NUMBER: 23-019-02

Cloth Covers On Both Front Seat Cushions May Loosen And Wrinkle

2002	(WJ)	Grand Cherokee
2002	(WG)	Grand Cherokee

Fig. 1 LOOSE SEAT COVER CLOTH

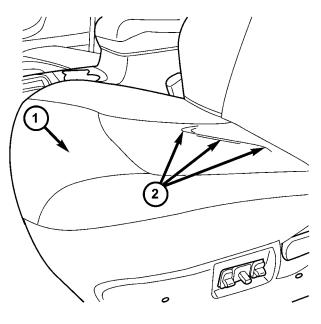
One or both front seat cushion pad(s) may sink away from the cloth seat cover and towards the seat frame. When this occurs the seat cover material may loosen. The excess seat cloth material may gather near the center of the seat cushion and appear as a raised wrinkle (a tenting or bridging appearance).

1. Replace both front cloth seat cushion covers and pads. For more detailed instructions, refer to the Body - Seats - Front Seat Cushion/Cover Section in the appropriate 2002 Grand Cherokee Service Manual (WJ or WG) (Fig. 1).
